11757B-02

S E R V I C E N O T E

HP 11757B Multipath Fading Simulator

DATE: 12 August 1993

11757B-02 Modification Diagram

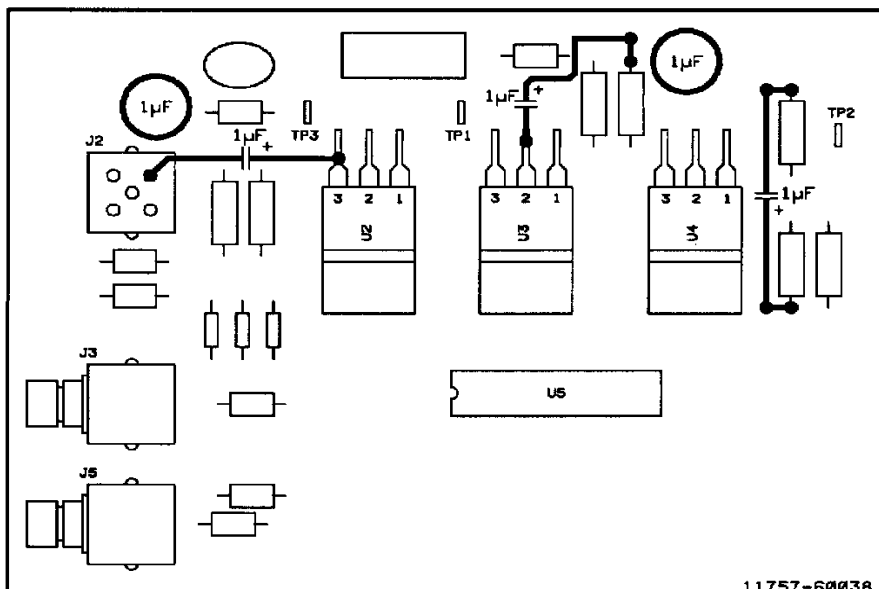
Some spurs 50KHz - 300KHz offset from the carrier, greater than the -67dBc specification for the RF source were observed on a few production units (11758). The problem was isolated to the EEPROM/Counter Board, both the current (11757-60056) and older (11757-60038) assemblies, on the U2, U3, and U4 regulators. The fix was to add 1uF capacitors to the input and output of the regulators as described in the regulator's application notes. This makes the regulators optimally stable and eliminates oscillations which were causing the spurs on the RF source's signal. The older board (11757-60038) can be retrofitted with a field installable modification (described in this service note) rather than replacing the board with its direct replacement, the Counter/EPROM Upgrade Kit (11757-60059). This eliminates the need to scrap the old board and order both the new board and new firmware contained in the kit. The updated older board (11757-60038) will become 11757-60061 after the fix is implemented. Similarly, the 11757-60056 can be modified and would become 11757-60060.

1. Place board on a bench equipped with an ESD mat. Make sure person performing this modification is grounded also. Observe all normal ESD precautions while this procedure is being followed.
2. Make sure that all exposed capacitor leads are covered with the insulating tubing to prevent contact with other points on the board.
3. Attach the non-polarized lead from a 1uF capacitor (0180-4129) to pin 2 of U3 and solder it.
4. Unsolder the lead of R7 closest to the edge of the pc board and solder a post connector into the hole. Re-attach R7 to the post as well as the polarized (plus) lead of the 1uF capacitor that was soldered to U3 pin 2.

5. Unsolder opposing leads of R30 and R10 (see diagram) and solder post connectors into both locations. Re-attach respective leads for R30 and R10 as well as leads for a 1uF electrolytic capacitor (0180-4129). Make sure polarized (plus) end of the capacitor goes to the R30 lead.

6. Attach the polarized (plus) lead of a 1uF electrolytic capacitor (0180-4129) to pin 3 of U2 and solder it. Remove the solder from the J2 ground hole indicated on the diagram, insert the remaining capacitor lead and solder.

7. Remove both capacitors C11 and C9 and replace with 1uF capacitors (0180-3771). Note that since these are three-lead items, it does not matter which way the capacitors are oriented.

8. Type the appropriate board number (according to the above matrix) on the label and apply over the existing board number.
9. This completes the modification procedure. After board is reinstalled in the instrument, please repeat spur tests to confirm that spurs found in the 50KHz - 300KHz carrier offset region have been eliminated.
